APPLICATION FOR PERMIT TO DRILL OR REENTER

2. Name of Operator EOG RESOURCES INCORPORATED (2377)		7. If Unit or CA Agreement, Name and No.
3a. Address 1111 Bagby Sky Lobby2 Houston TX 77002	3b. Phone No. (include area code) (713)651-7000	8. Lease Name and Well No. (320792) DELLA 29 FEDERAL 604H

ADDENDUM - Incomplete/Deficient

Exhibit 1a

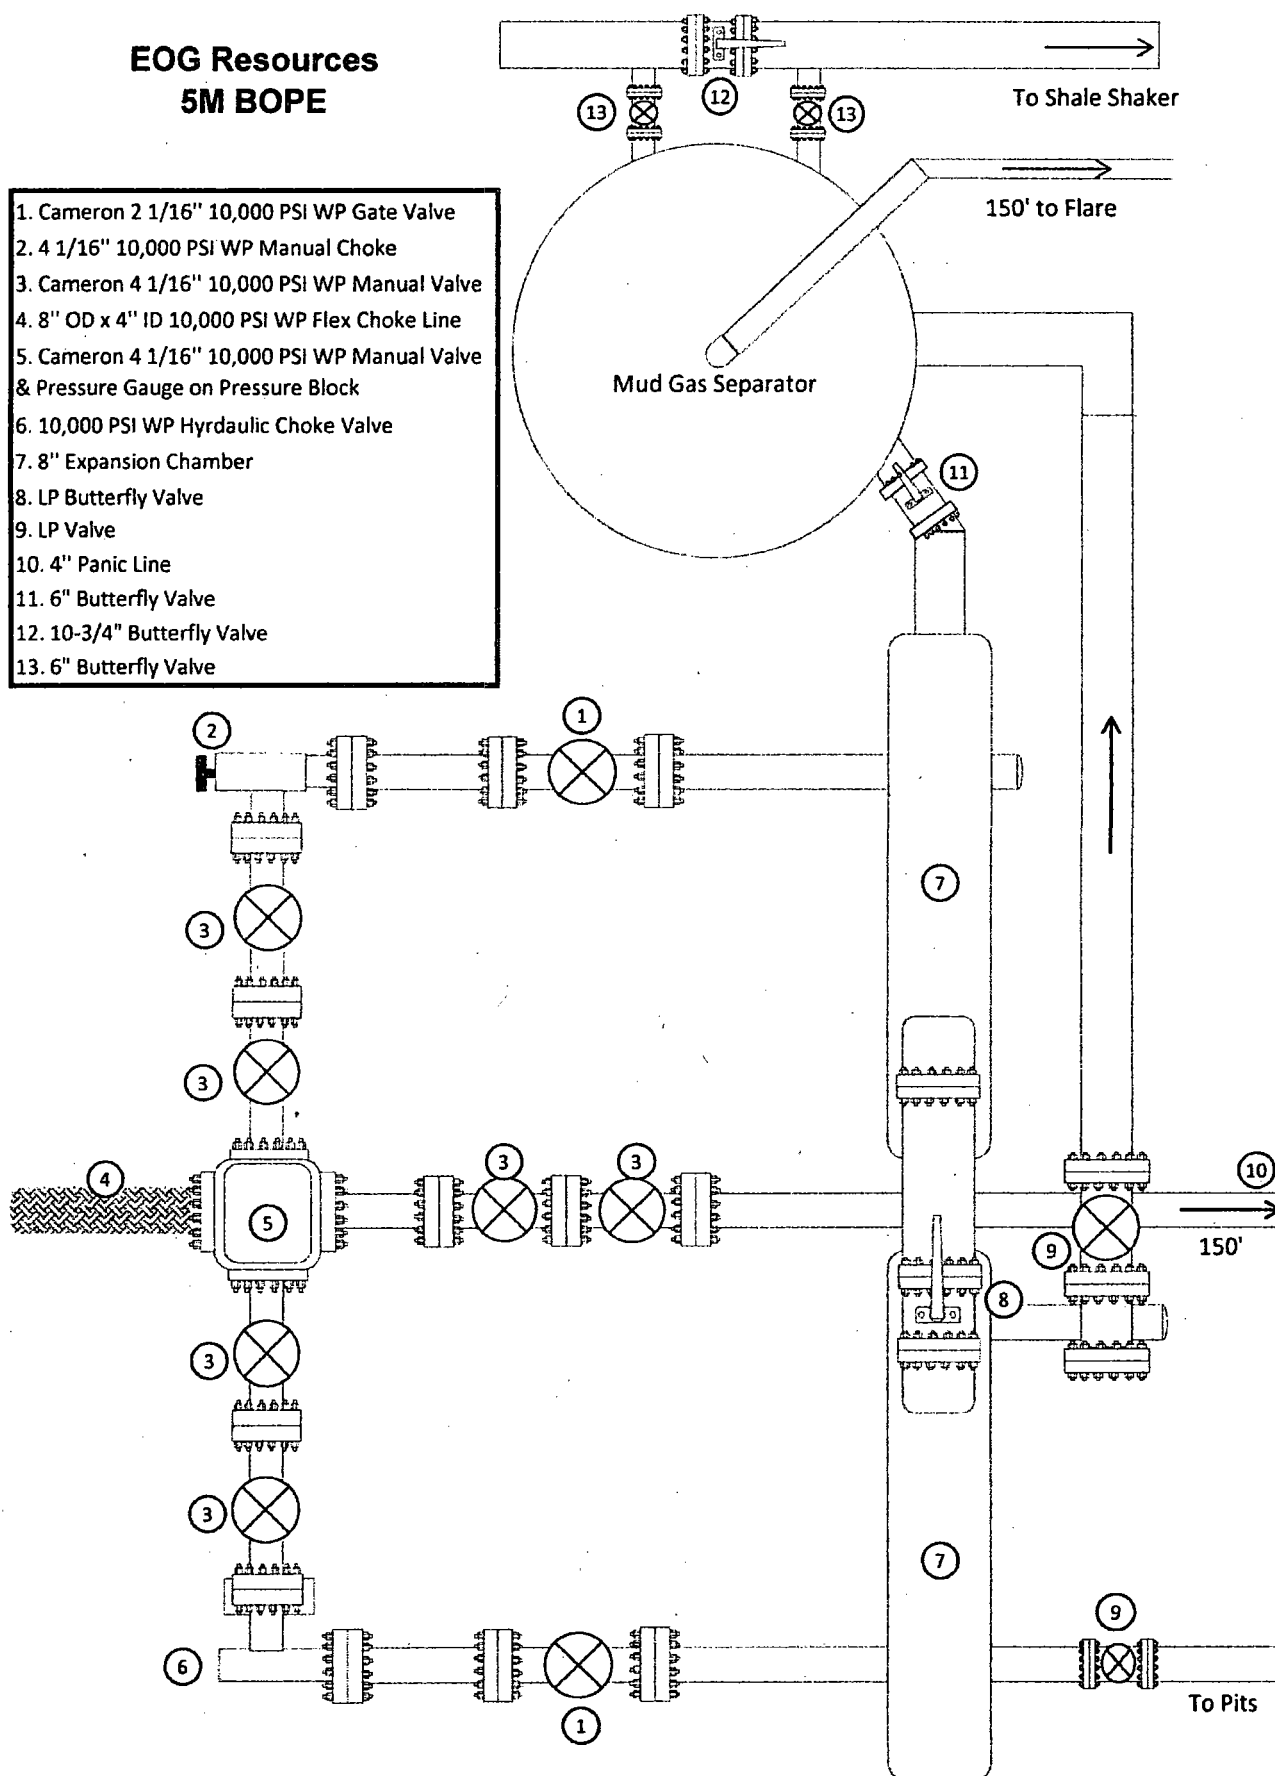
- BOP requirements are not met
Choke manifold need another outlet to the shaker. *Attached to drill plan*

- * I spoke w/ Vance Wolf on 10/31/17 and again on 11/29/17.
Della wells are on a drill island in the potash area.
EOG will coordinate w/ Jim Amos areas offsite to reclaim.
These areas are unknown at this time.
